RFB-2024-39
INTERIOR RENOVATIONS TO SCHENECTADY COUNTY DEPW
C2 DESIGN GROUP

ADDENDUM #3

Issued Date: 08/02/2024

1 FIRST FLOOR DEMOLITION PLAN (OVERALL) - PLUMBING

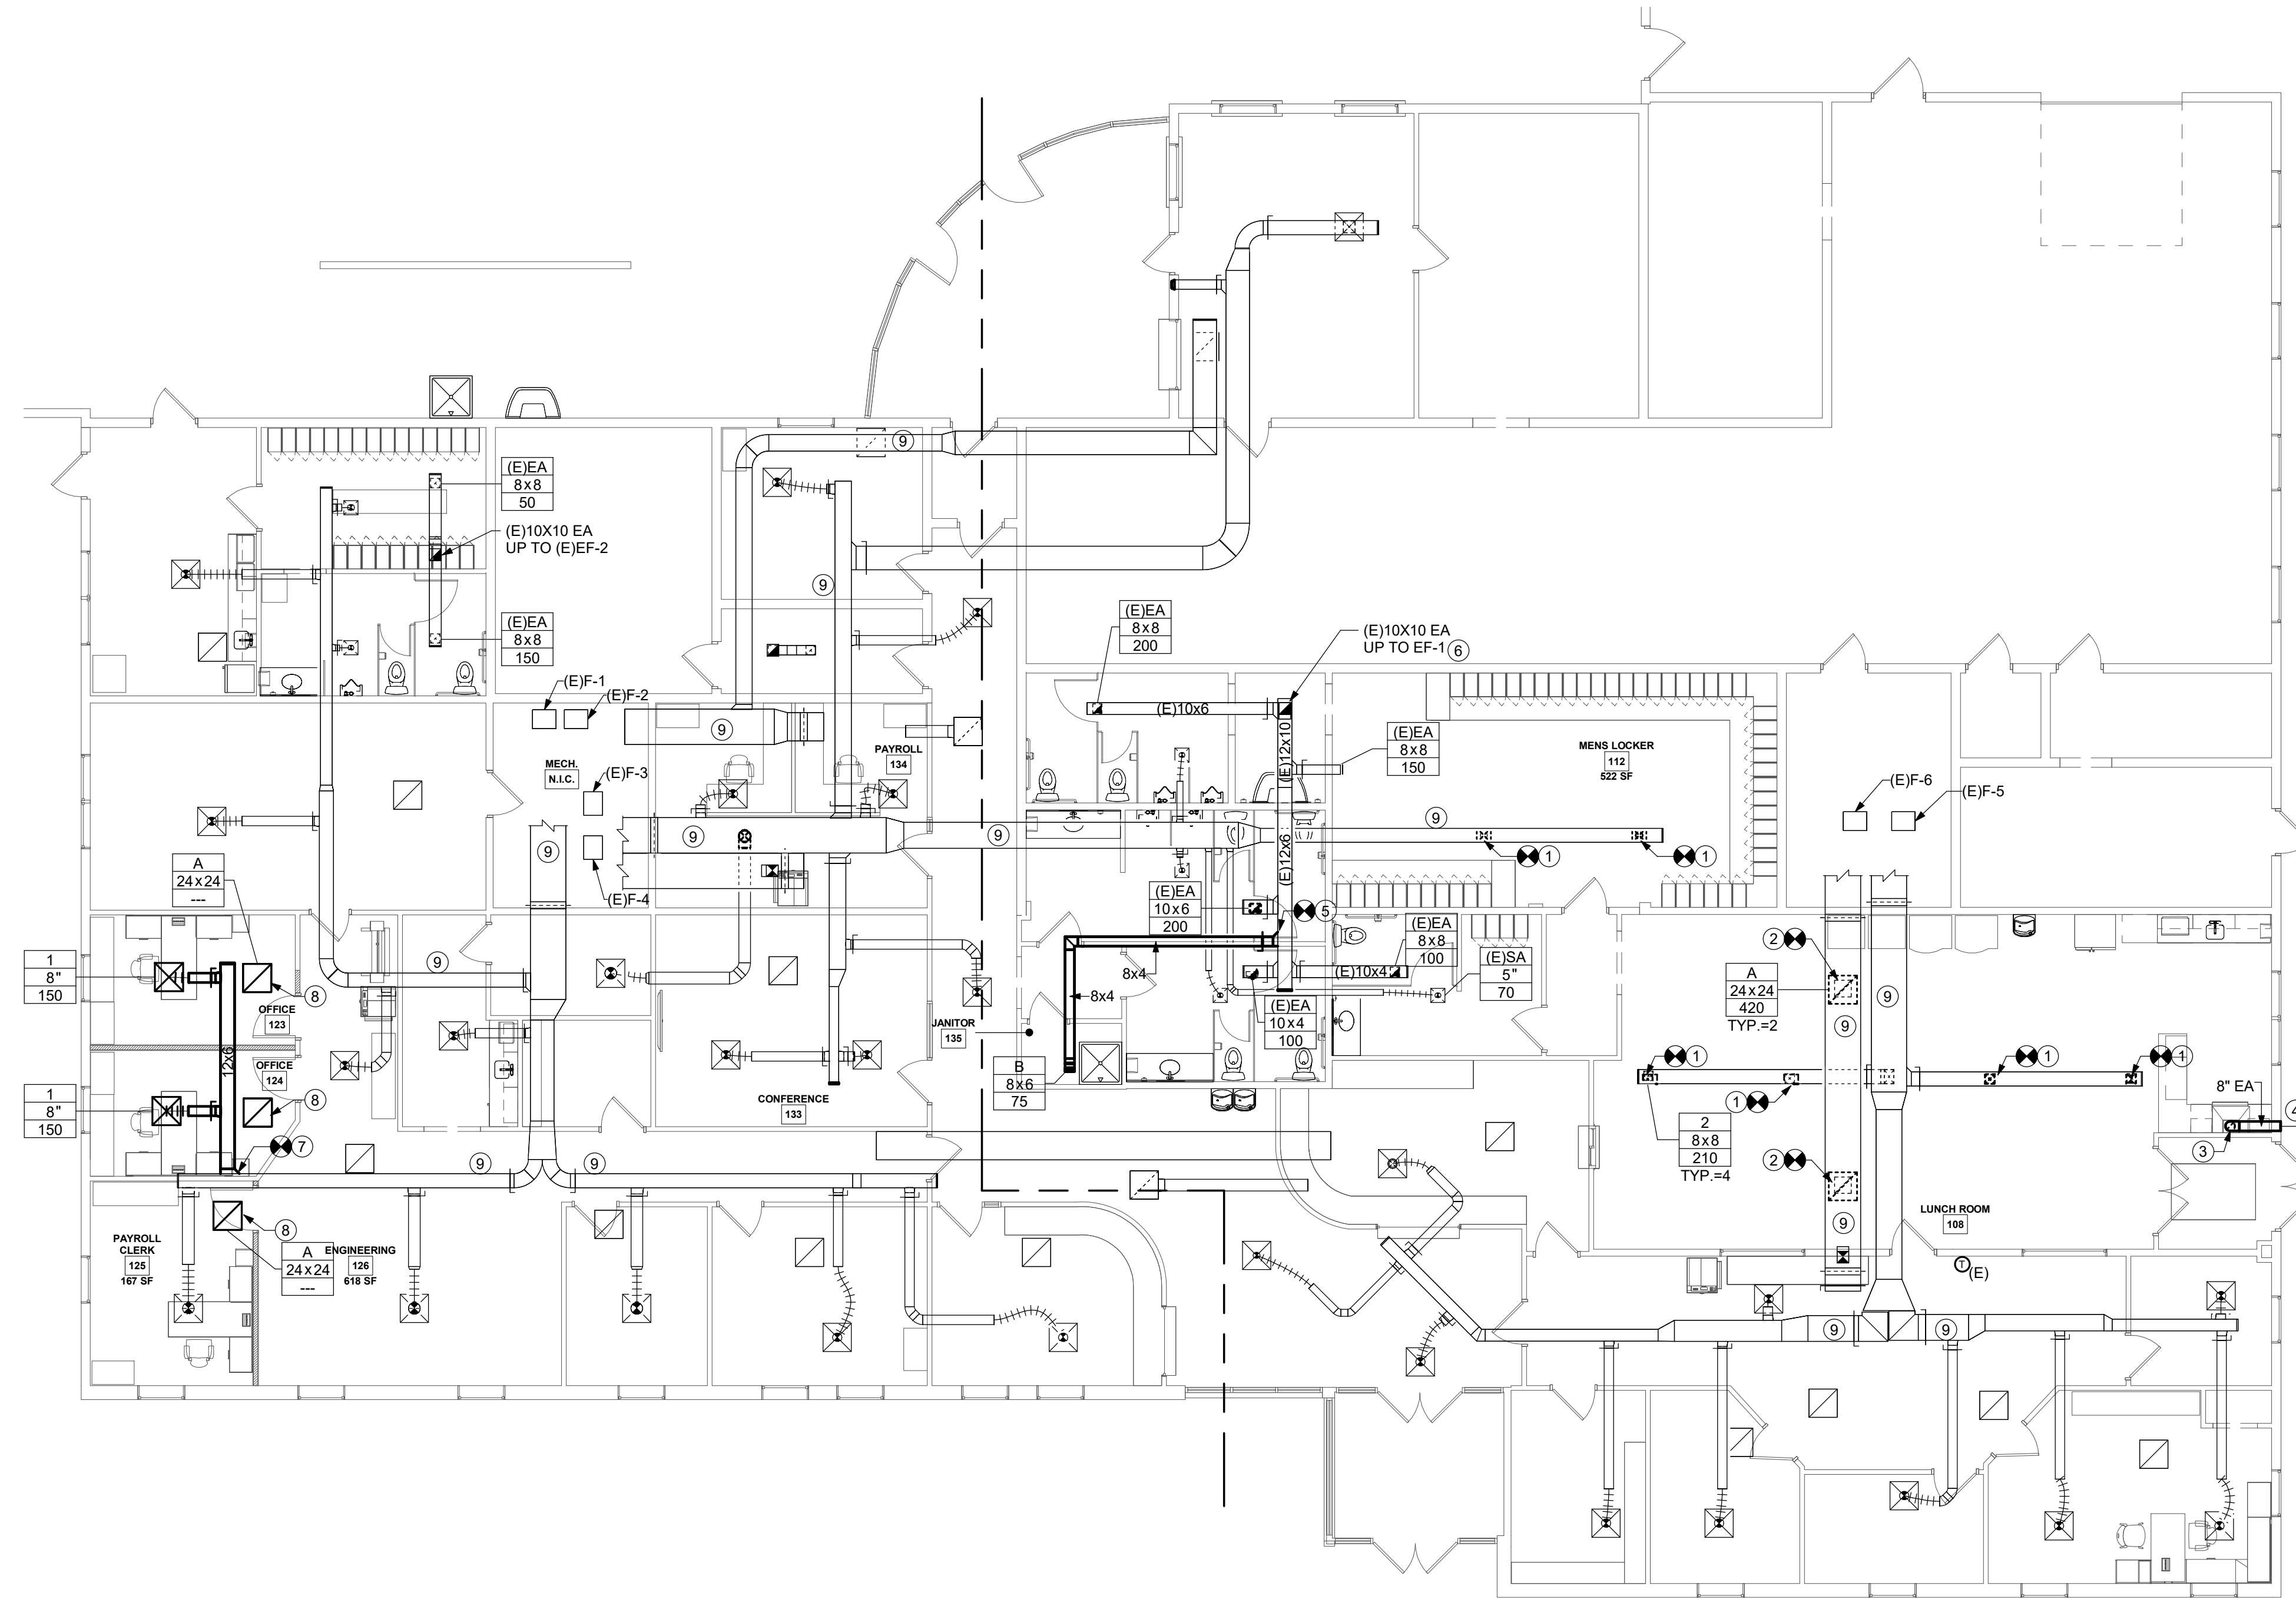
- a. Reference for EWC-A
8. Drawing PD101 – First Floor Demolition Plan - Plumbing
 - a. Reference demo. of existing water cooler
9. Drawing M101 – First Floor Plan (Overall) - HVAC

- 10 DISCONNECT AND REMOVE EXISTING DRINKING FOUNTAIN AT THIS LOCATION. PREPARE EXISTING WASTE AND COLD WATER SUPPLY LINE FOR CONNECTION TO NEW DRINKING FOUNTAIN.

M101

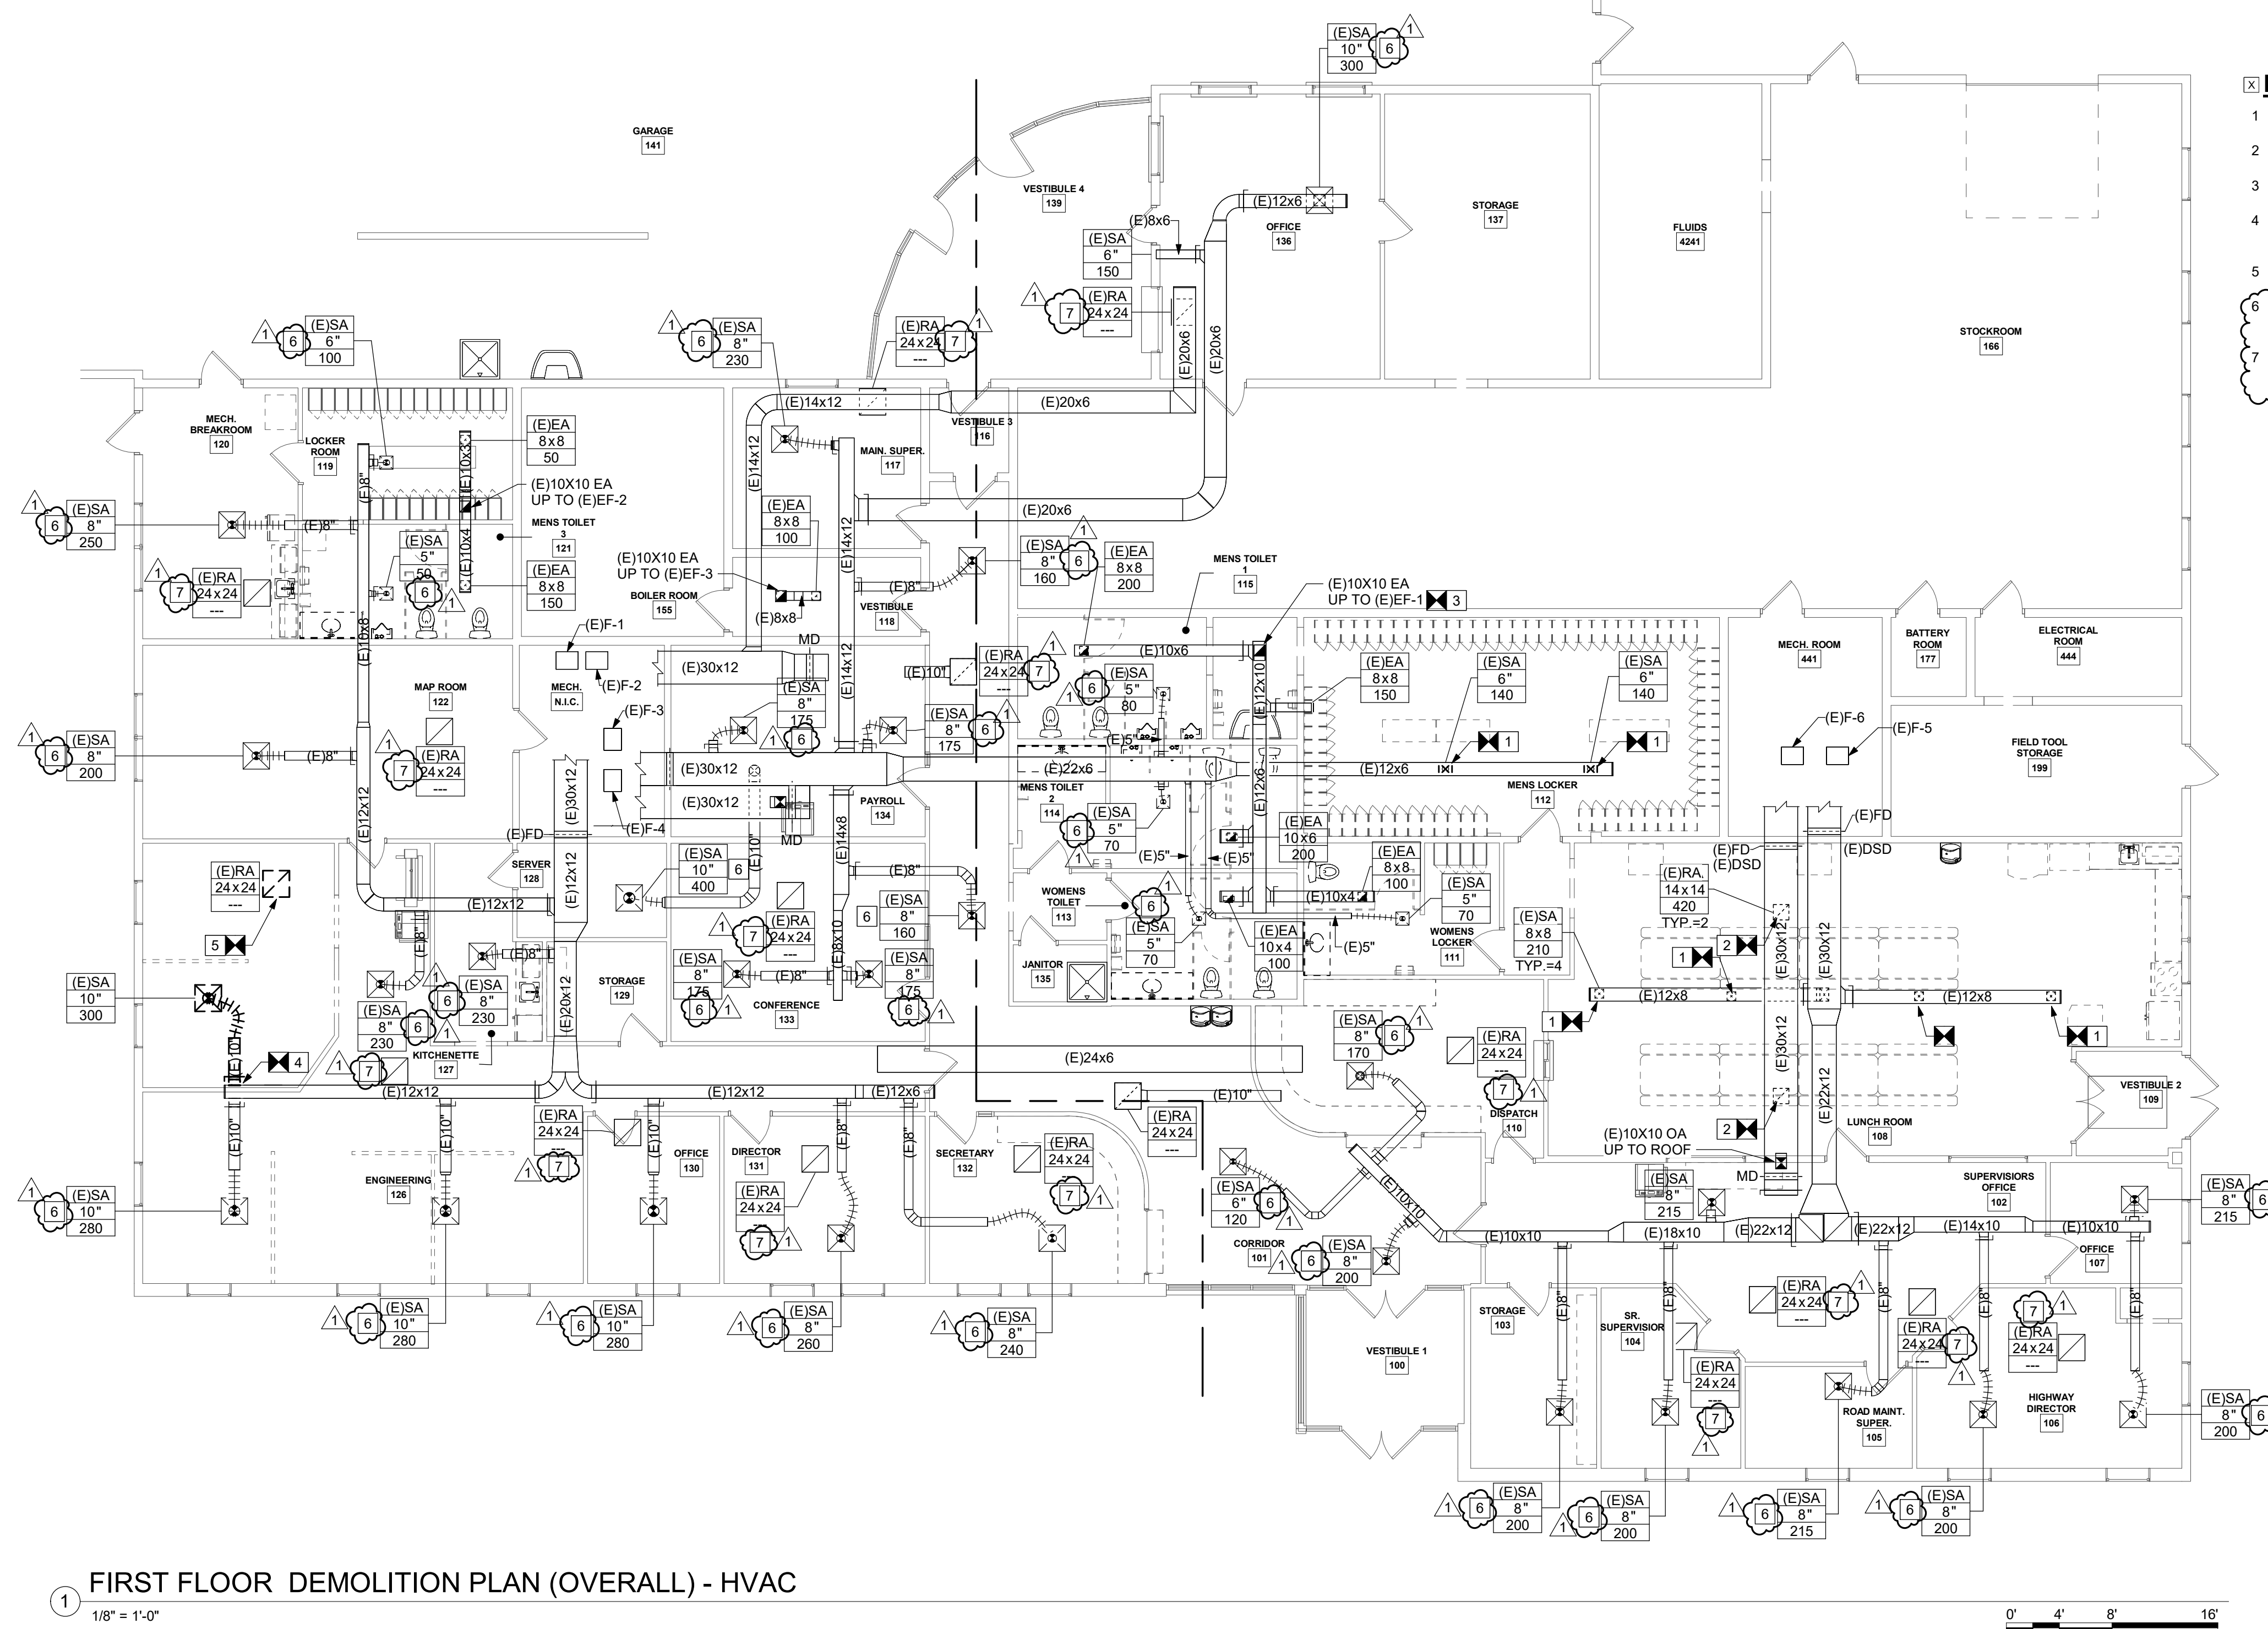
- a. Reference drawing note for Duct Cleaning
10. Drawing MD101 – First Floor Demolition Plan (Overall) - HVAC
 - a. Reference Demolition note for replacement of Supply Diffuser and Return Grilles

- 1 PROVIDE NEW SUPPLY AIR TERMINAL AT THIS LOCATION.
- 2 PROVIDE NEW RETURN AIR TERMINAL AT THIS LOCATION.
- 3 PROVIDE 6" EXHAUST AIR DUCTWORK PER SPECIFICATIONS. CONNECT TO EXHAUST HOOD AND ROUTE TO EXTERIOR.
- 4 PROVIDE WALL CAP AND BACKDRAFT DAMPER AT THIS LOCATION. SEAL PENETRATION WEATHERTIGHT.
- 5 CONNECT TO EXISTING EXHAUST DUCTWORK AT THIS LOCATION.
- 6 PROVIDE NEW EF-1 ON ROOFTOP AS SPECIFIED.
- 7 CONNECT TO EXISTING SUPPLY AIR DUCTWORK AT THIS LOCATION.
- 8 PROVIDE NEW RETURN AIR TERMINAL AT THIS LOCATION (LAY IN CEILING GRID).
- 9 PROVIDE DUCT CLEANING PER SPECIFICATIONS FOR THE SUPPLY AND RETURN OF THIS SYSTEM.
